Re: City of Phoenix Comments on West Van Buren ("WVB") WQARF Site  
Roosevelt Irrigation District ("RID") Early Response Action Work Plan

## **Comments Upon and Recommendations for Assessing Risk in the West Van Buren WQARF Area**

FIGURE 1

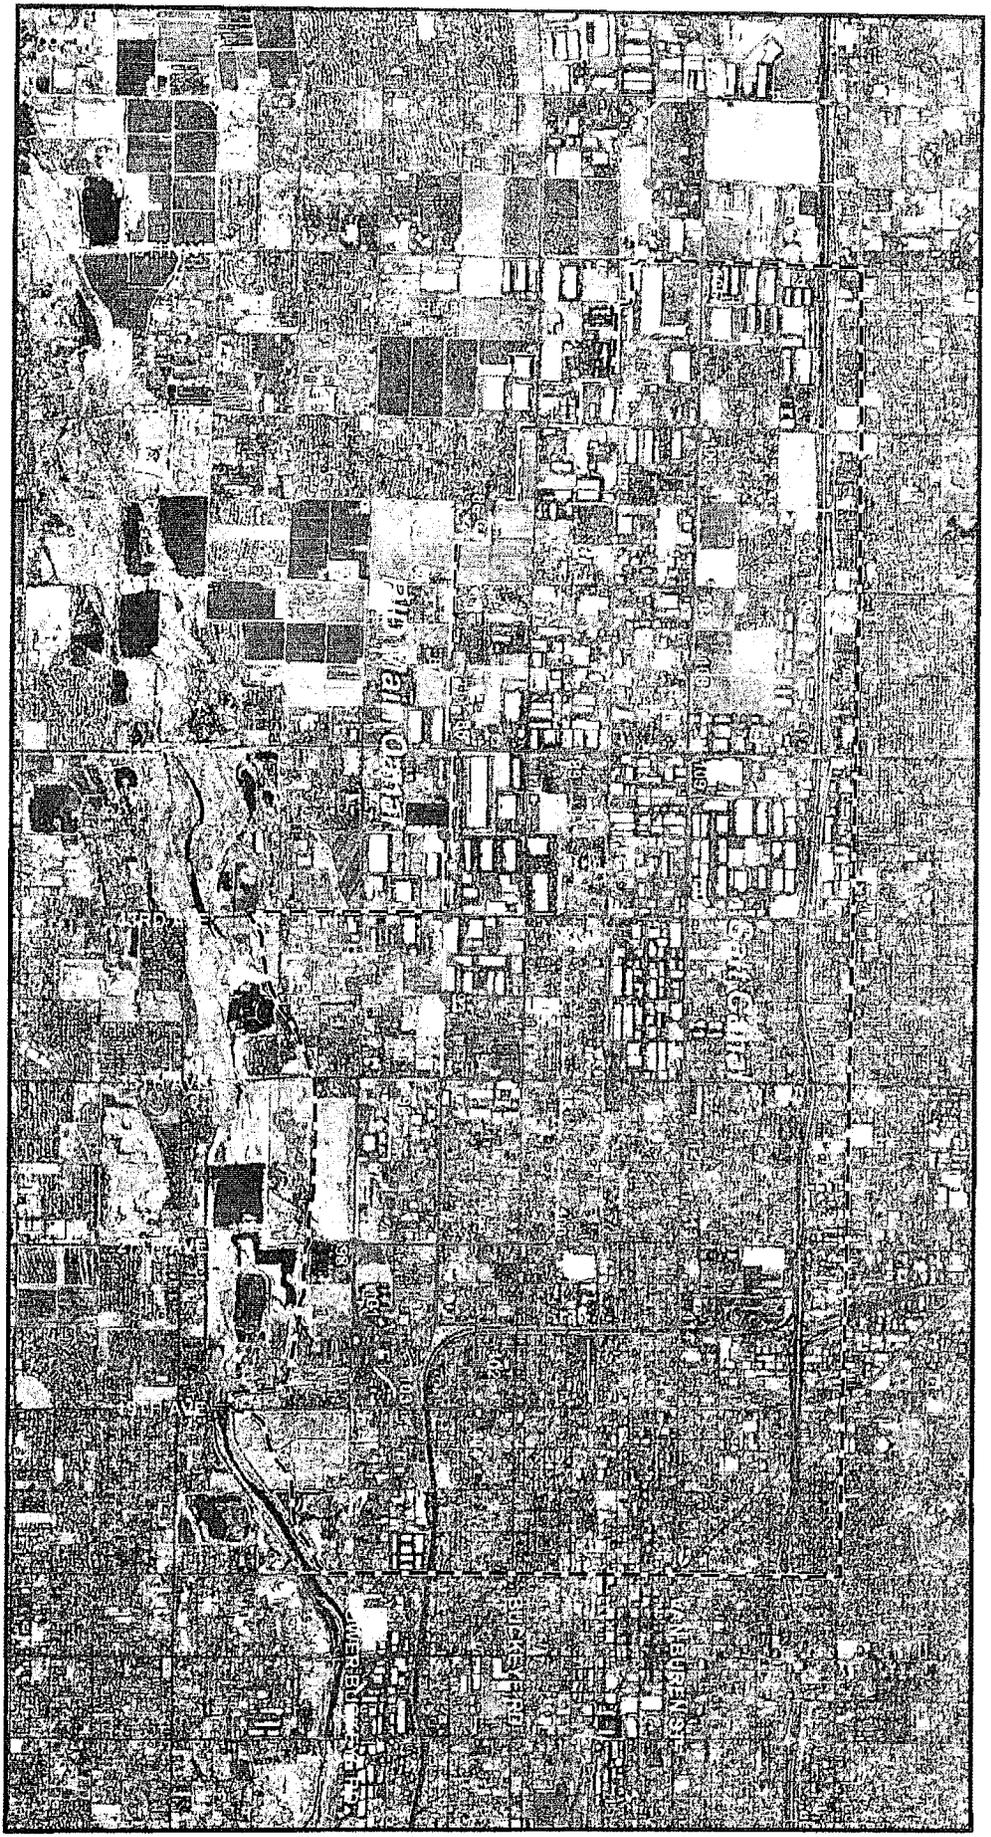
Of the 31 RID wells in the WVB WQARF area, 13 wells discharge directly to the RID Main Canal, 8 wells discharge to Main Canal laterals, and 10 wells discharge to the Salt Canal (Figure 11). Groundwater sampling data from the RID wells have been collected on numerous occasions. Table 1 summarizes TCE, PCE, and 1, 1 DCE groundwater sampling data for September 2008 from RID wells within the WVB WQARF area (based on the February 3, 2010 Revised RID Work Plan). For the RID Salt Canal wells, TCE concentrations ranged from <0.58 to 85 µg/l, with an average concentration of approximately 18 µg/l; PCE concentrations ranged from 3.9 to 39 µg/l, with an average of approximately 11 µg/l; and 1, 1 DCE concentrations ranged from <0.50 to 7.4 µg/l, with an average of approximately 3.1 µg/l. Of the wells sampled on the RID Main Canal, one well, RID-84, contained detectable levels of TCE (1.3 µg/l), PCE (9.4 µg/l) and three wells (RID-84, RID 101, and RID 103) contained detectable levels of 1,1 DCE ranging from 0.85 to 2 µg/l. For wells located on the RID Main Canal Laterals, TCE concentrations ranged from < 0.5 to 85 µg/l; PCE concentrations ranged from 1.2 µg/l to 19 µg/l; 1, 1 DCE concentrations ranged from <0.5 to 9.3 µg/l.
